ORIGINATION FORM

Proposed Revisions to a Standard Plans Index
(Please provide all information — Incomplete forms will be returned)

Index Number: 700-120

Index Title: Enhanced Highway Signing Assemblies

ROADSIDE SIGN ASSEMBLY-7

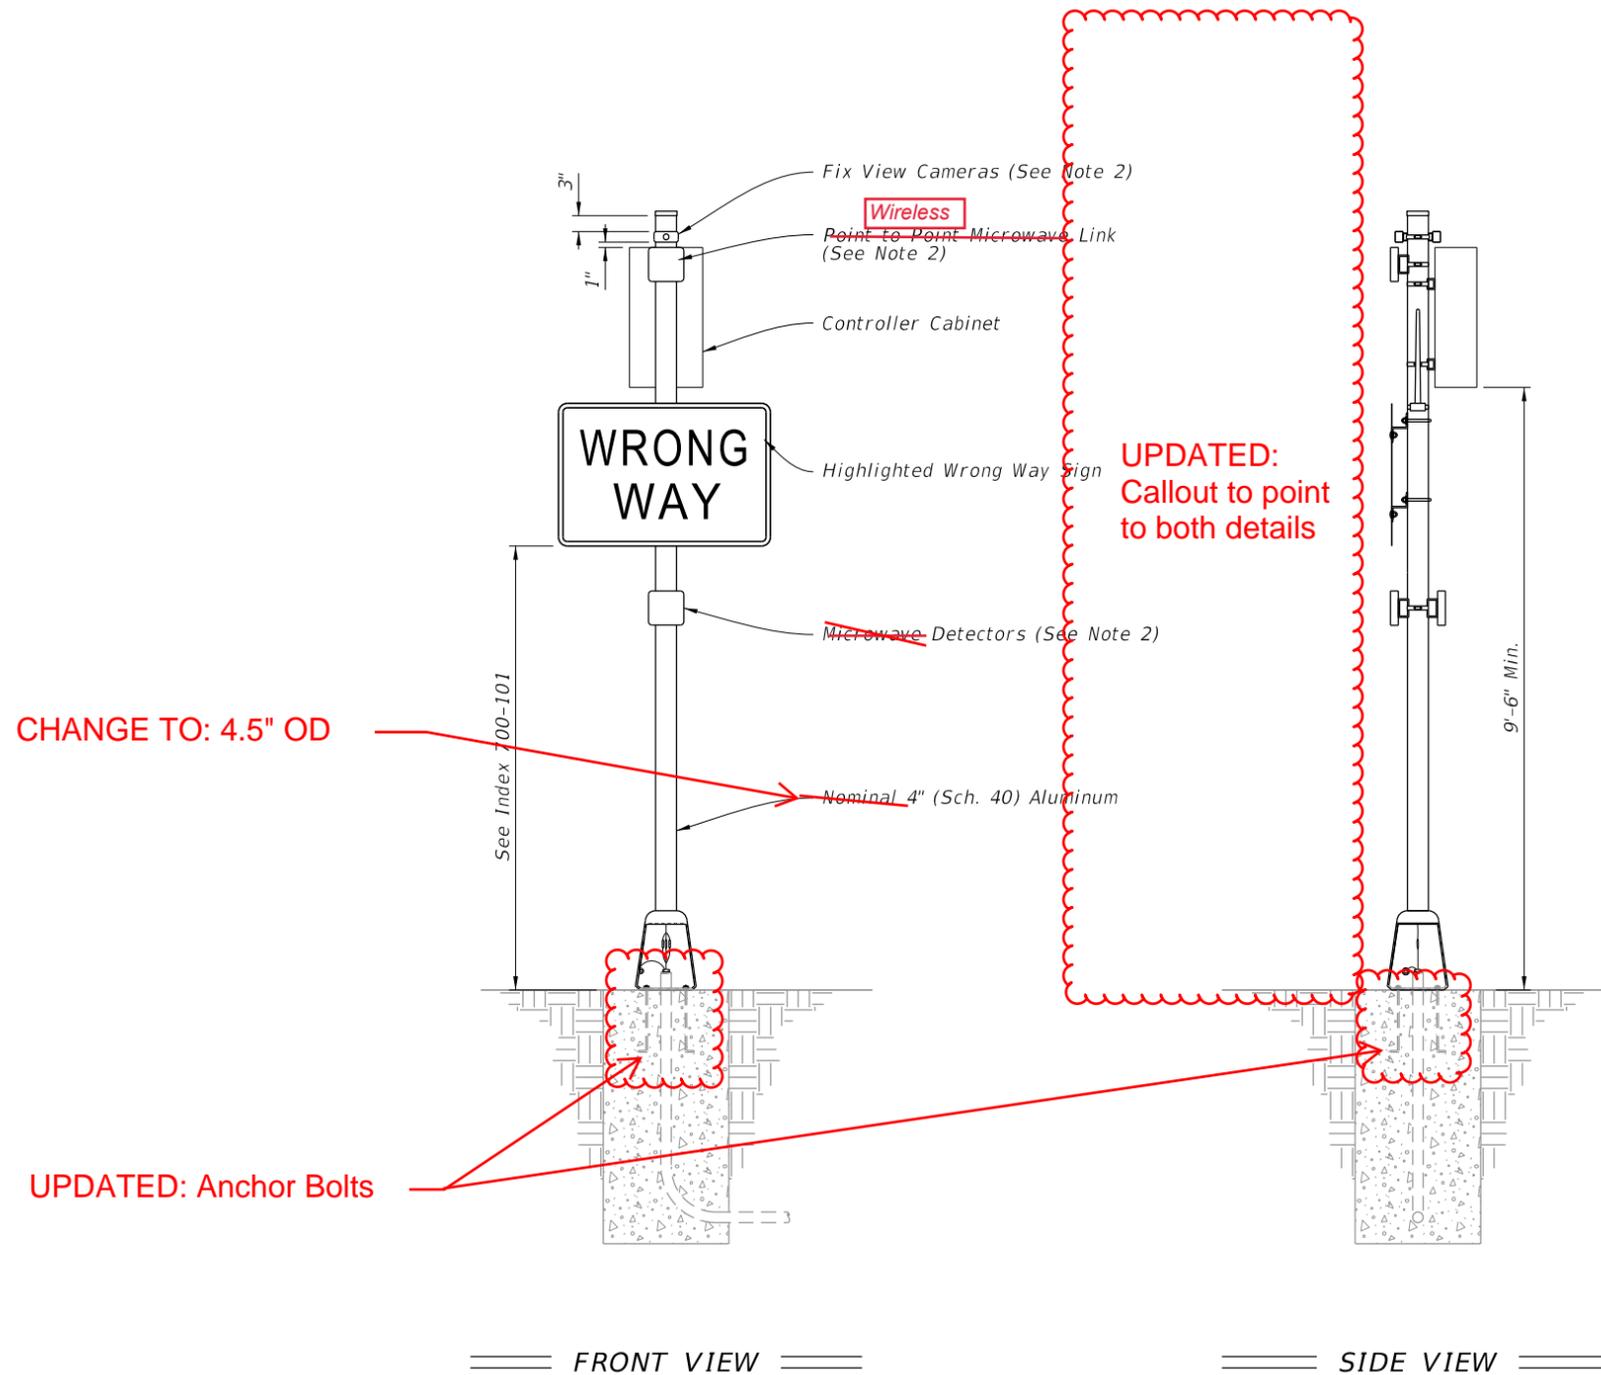
Sheet 9 - Change "Point to Point Microwave" to "Wireless" from the FRONT VIEW and from Note 2.
Remove "Microwave" from the FRONT VIEW and from Note 2.

Sheet 9 - The manufacturers have been using omnipolar wireless links between assemblies instead of point-to-point microwave links. Agencies have been using other forms of detection instead of microwave. The Wrong Way Vehicle Detection System detectors shall be nonspecific.

1. Type A7 Assembly (Conventionally-Powered) is shown.
2. Install cameras, **wireless** ~~point to point microwave link~~, ~~microwave~~ detectors, and antennas in accordance with the manufacturer's instructions.
3. For solar powered assemblies, install controller and batteries in the same ground mounted cabinet. Install a separate pole for mounting the solar panel. Install the solar panel pole and cabinet as close to the right of way boundary as possible. Orient solar panel to face South.

ADDED NOTE:

Foundation reinforcement not shown.

ROADSIDE SIGN ASSEMBLY-8

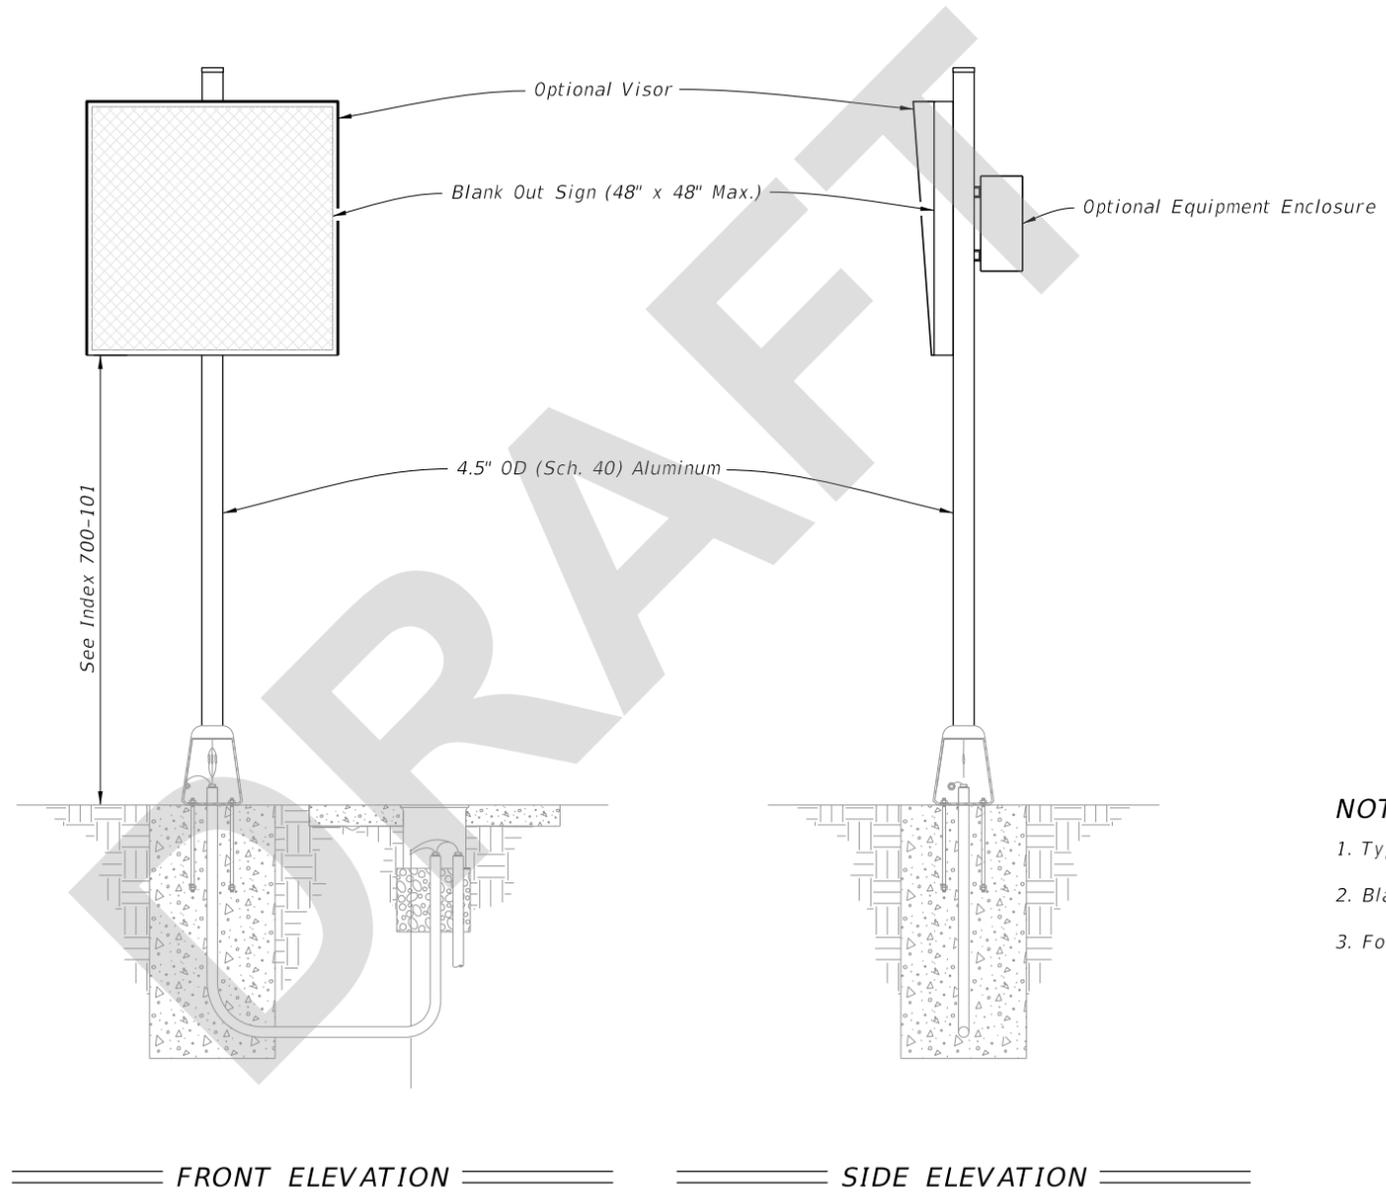
New Sheet 10 - New sheet for Roadside Sign Assembly-8, Blank Out Signs.

New Sheet 11 - Traditionally, Blank Out signs have been installed on traffic signal mast arms. To allow flexibility in installation, the roadside mounting option is being proposed.
